DESIGN REVIEW BOARD FEBRUARY 17, 2017

DESIGN REVIEW BOARD JANUARY 6, 2017

DESIGN REVIEW BOARD JANUARY 20, 2017

SIDE (WEST) ELEVATION

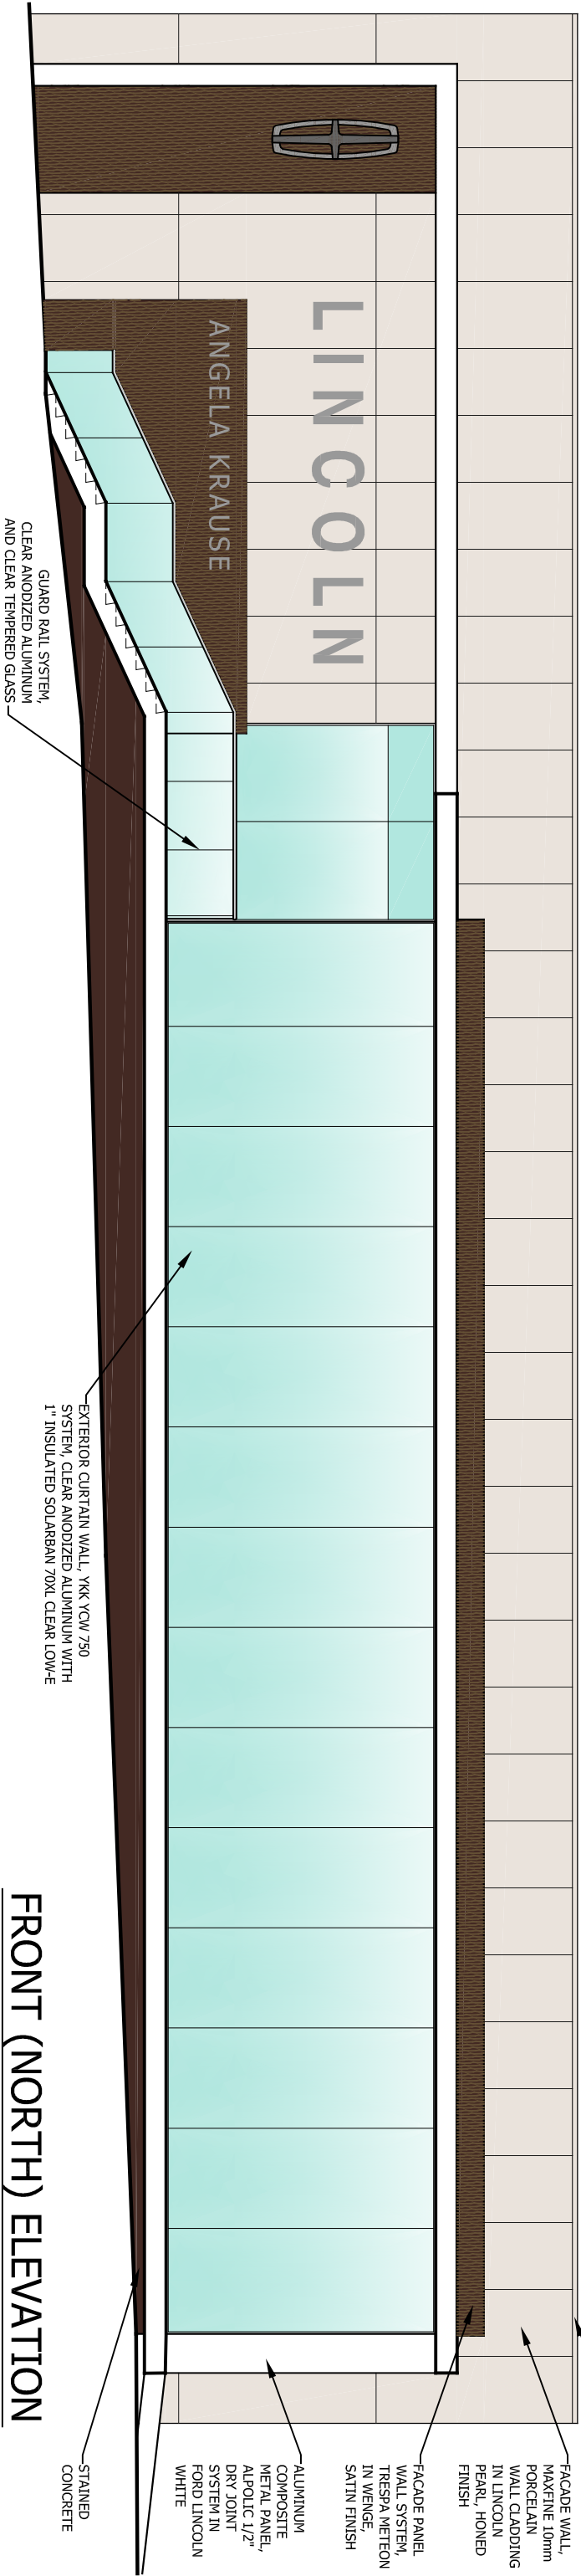
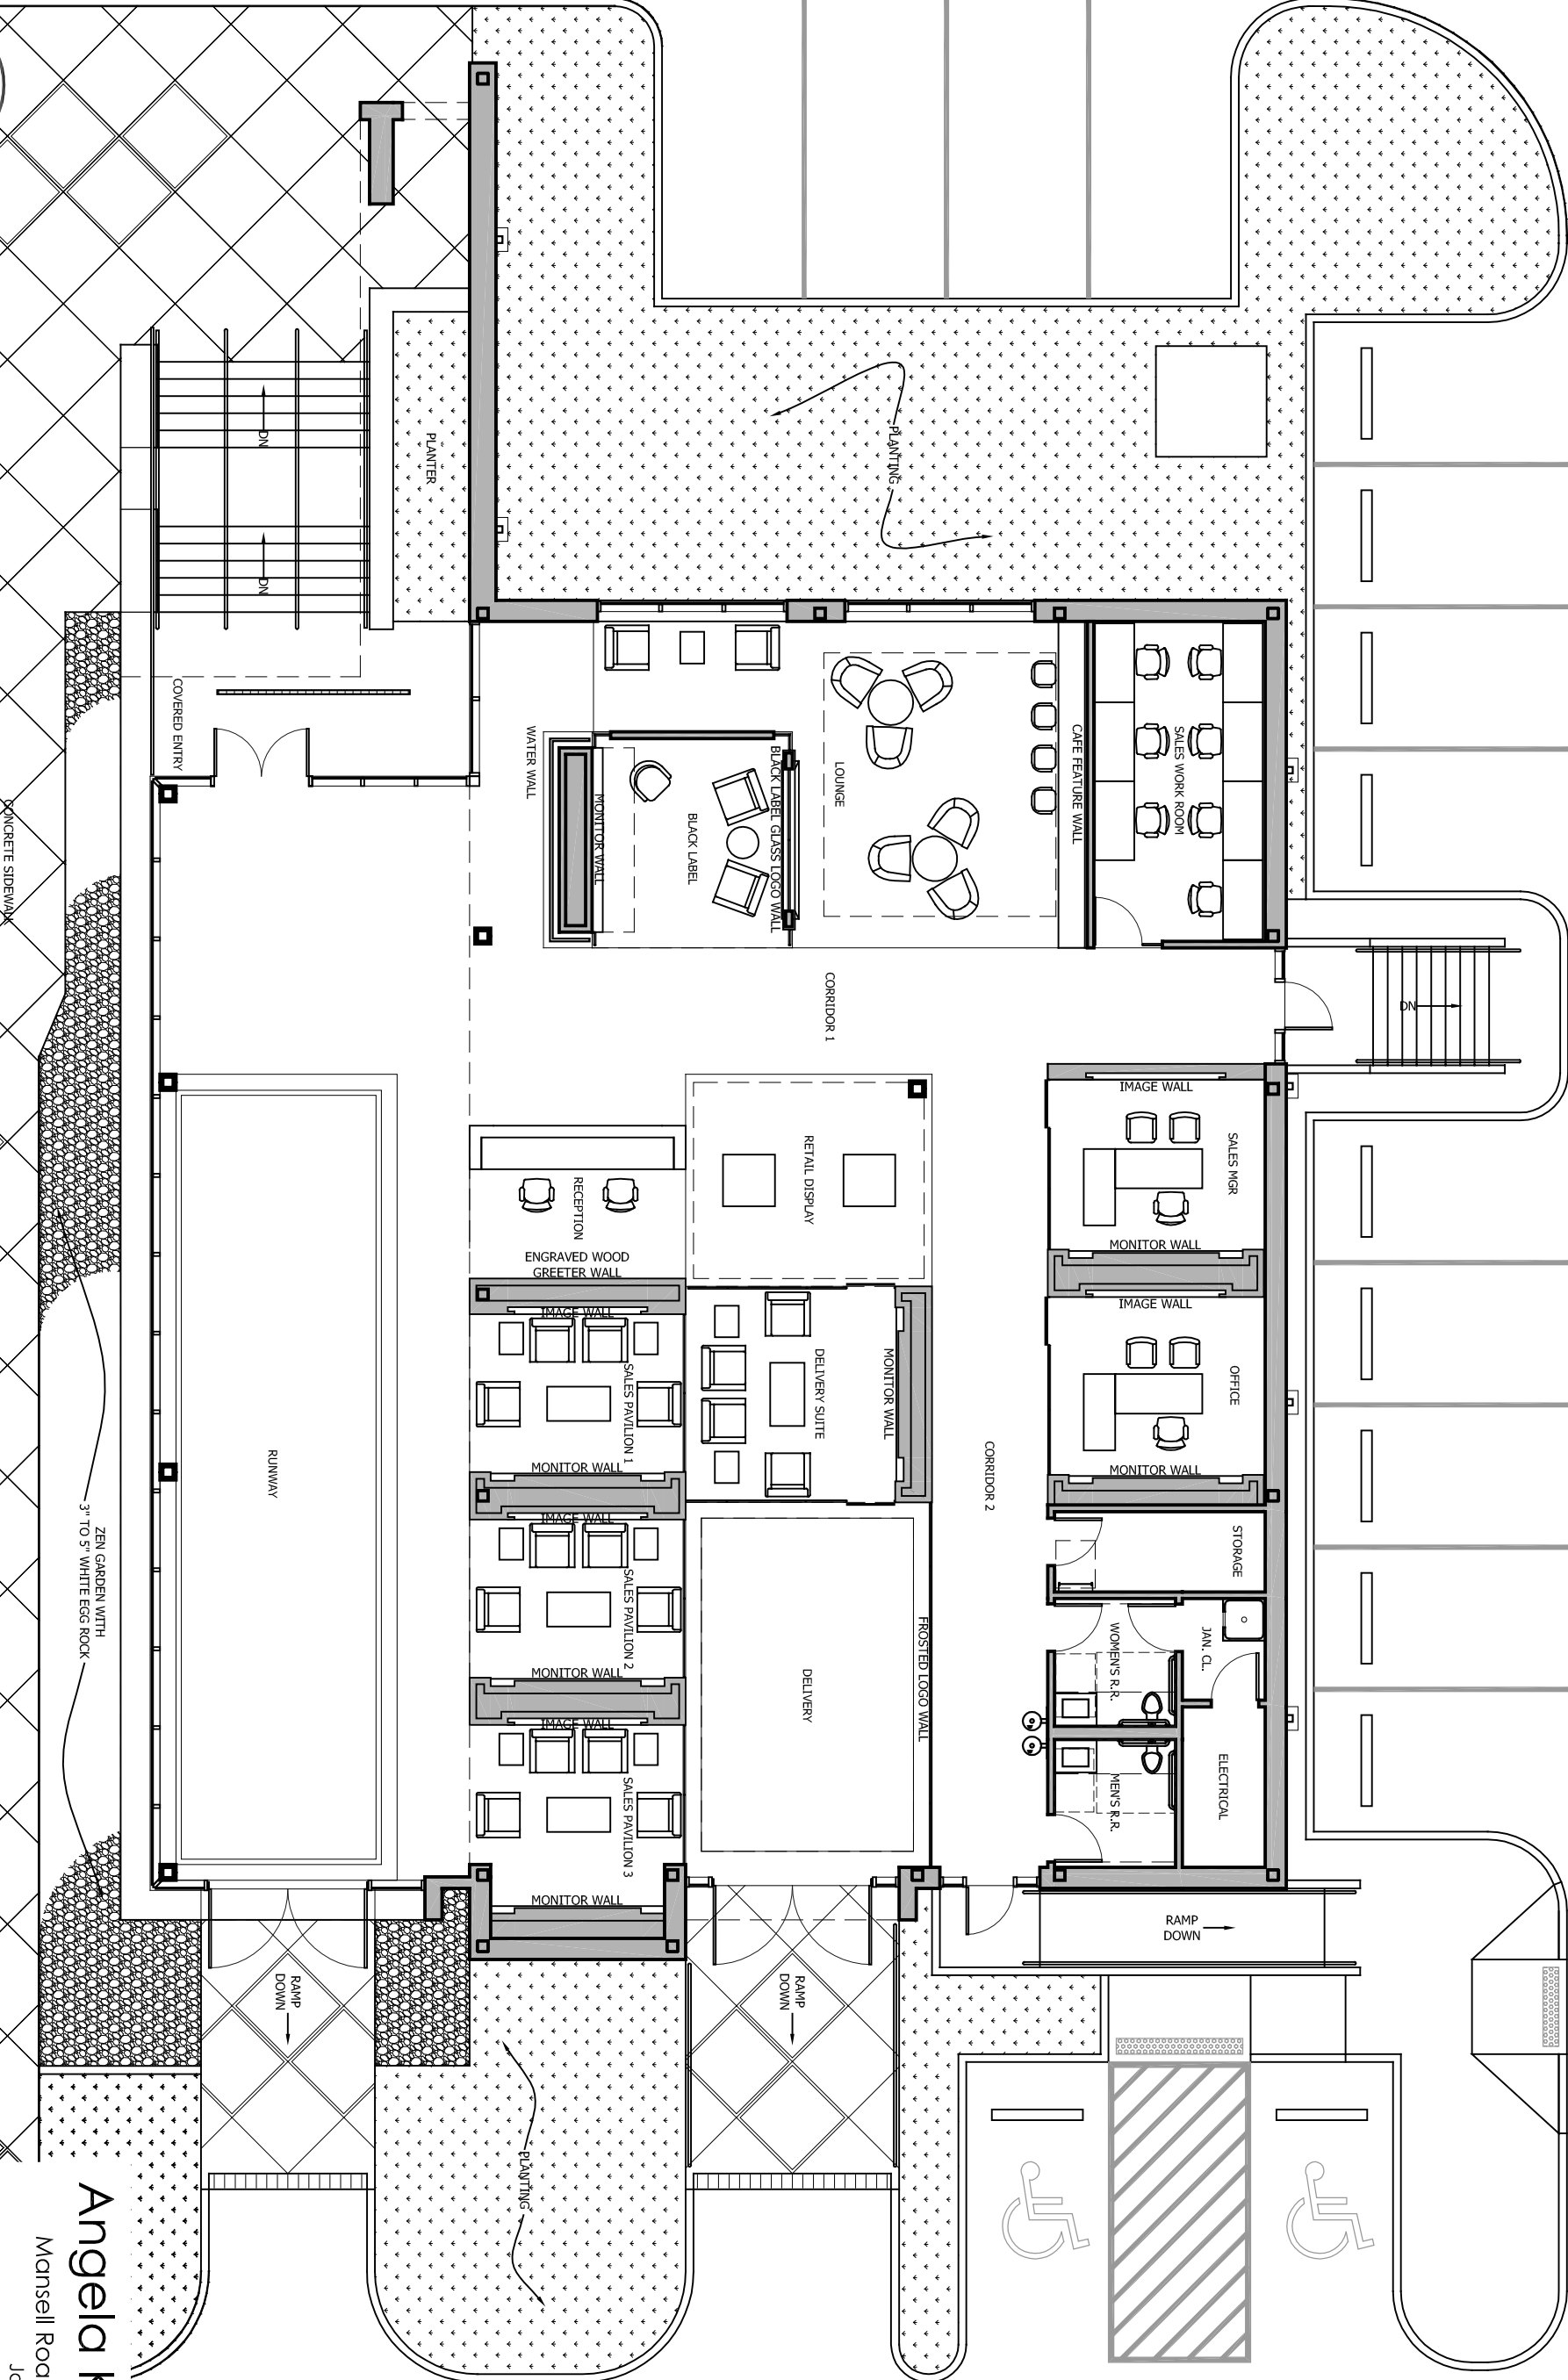
- Parking Islands
- Parking Lot Screening
- Conceal “getaway railing” with landscaping with Evergreen material
- Zen Garden concept unclear
- Exterior Elevations preliminary design document
- Height of Building- 22-‘24’ approximate
- DRB would like to see pictures of one that has been built
- No external raised car display
- Parking lot lighting
- Site Lighting not complete at this time
- No plan for additional dumpster on the property
- Back right hand side of top elevation seemed blank. Applicant stated it is meant to match Ford dealership.
- Still working on building signage
- Blank block side elevations (lounge side) faces Ford
- DRB would like to see entire side elevation

❖ Board Member Brown offered a motion to approve the Site Plan and Landscaping conceptually with the direction that Applicant returns with the Zen Garden, the Building, Lighting, and Signage all at one time.

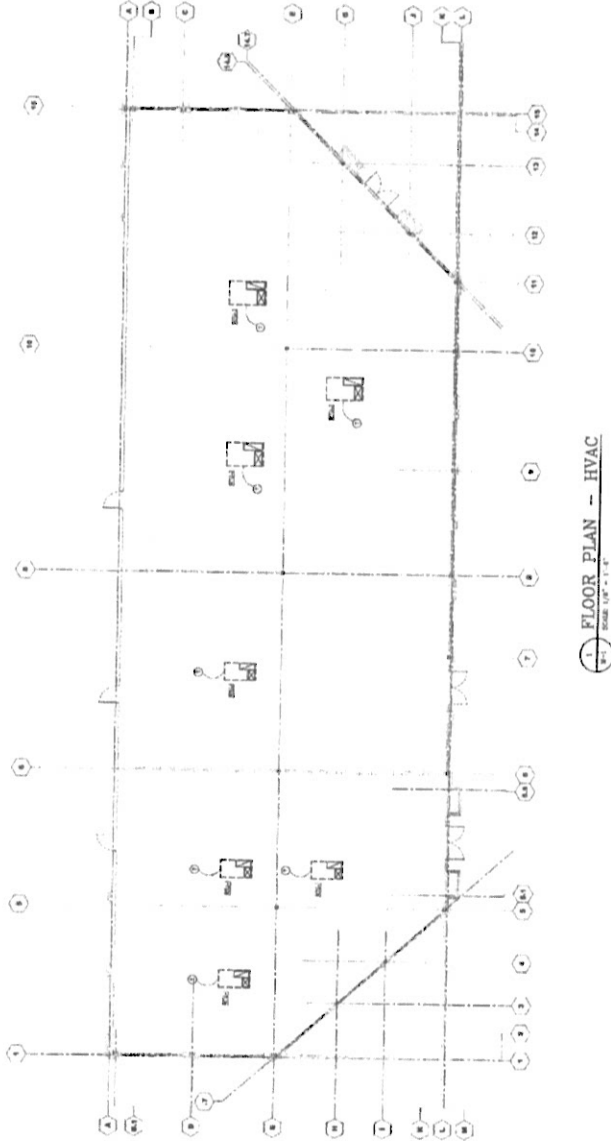
<i>Comment by</i>	<i>Date</i>	<i>Comment</i>
MWOODMAN	2/2/17	This item should not move forward in February as the use requires approval by Council. The item is scheduled to be heard by Council on February 27, 2017.
DSHOSTAK	2/14/17	Maintain or replace required parking lot island trees with 200 sq ft minimum soil surface or provide additional underground soil volume. Maintain "air" space for the canopy of these trees Provide evergreen screen around seating area.

site plan

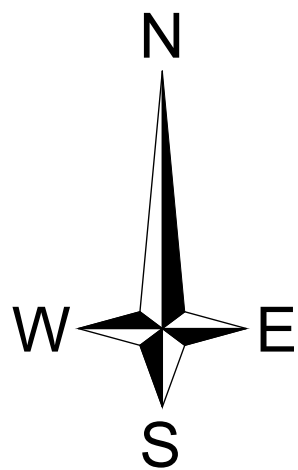
MWOODMAN	2/2/17	1. Where are the landscape plans? 2. Brookside MP requires a site to make efforts to minimize the amount of impervious parking surface. Code requires 66 parking spaces and they are proposing 86 spaces. I don't believe this site plan is compliant with this condition. 3. What is the side/rear setback shown on the site plan, not labeled. 4. 10' landscape strip required along Brookside Pkwy. 5. Site is covered in trees. I see no tree saves on the site plan. 6. Does this restaurant have a drive-thru? If so, the use is not permitted. 7. Building design requirements are included in condition #33 of the Brookside Master Plan. Not sure that the elevations meet this condition. Condition requires angled roof lines. 8. Parking lot landscape island is required for every 72' of parking length. Site plan does not comply in several locations.
----------	--------	--
